Historic Architectural Review Commission
Staff Report for Item 3

To:	Chairman Haven Burkee and Historic Architectural Review Commission Members
From:	Enid Torregrosa-Silva, MSHP Historic Preservation Planner
Meeting Date:	September 27, 2022
Applicant:	Robert A. Jensen, Owner
Application Number:	H2022-0030
Address:	411 Louisa Street

Modifications to front, side, and rear walls of an existing addition. Second-story addition at rear of property.

PROPOSED LEFT SIDE ELEVATION

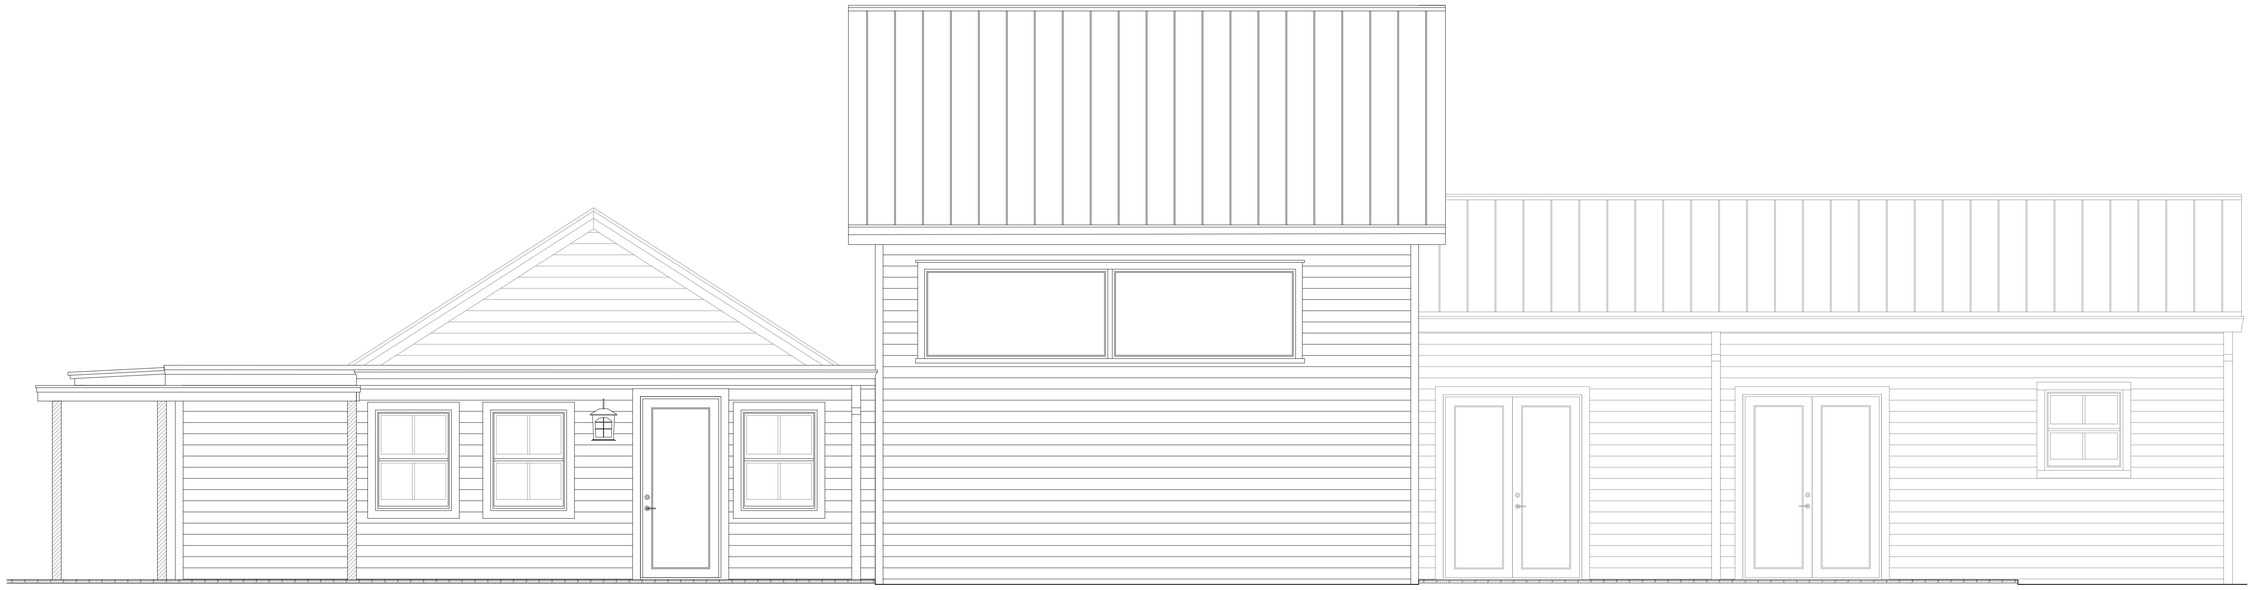
The revised plan still proposes changes to the front elevation which has two recessed entries on the first floor. The plan proposes having the recessed entries flush with the existing façade. New windows will replace existing double doors. One double door will be installed and will replace an existing window. The addition will have wood siding, aluminum windows and doors and 5 v-crimp metal panels for roofing.

PROPOSED REAR ELEVATION

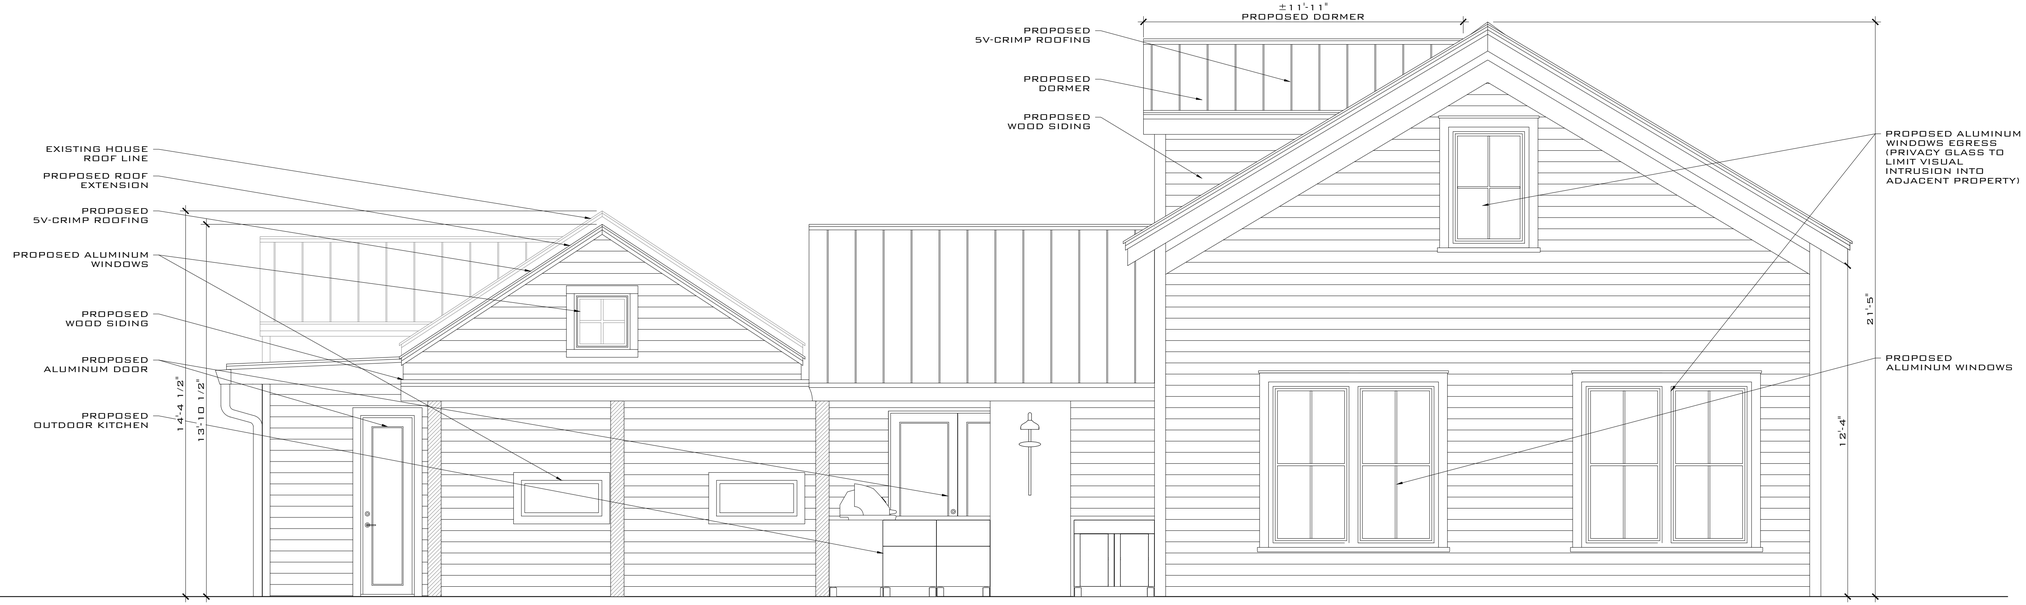
This report is for the review of changes to a previous design that was postponed during the September 12, 2022, special meeting. The applicant has submitted revised drawings that include decrease in height of the two-story addition. Eaves extend approximately 6 inches, which will increase the rear yard setback from 4' to 5'. The height of the proposed addition will be of same height as the existing one and a half story, which is approximately 21'-5". To gain interior height, the design includes two dormers on the north gable. The proportions of the gables are like the house adjacent to the south side of the property. The proposed addition still includes annotations for wood siding, aluminum windows and doors and 5 v-crimp metal panels for roofing.

The applicant reduced the height of the new addition as requested by the Commissioners during the last meeting. Addition will still be approximately 5'-6" setback from rear property boundary.
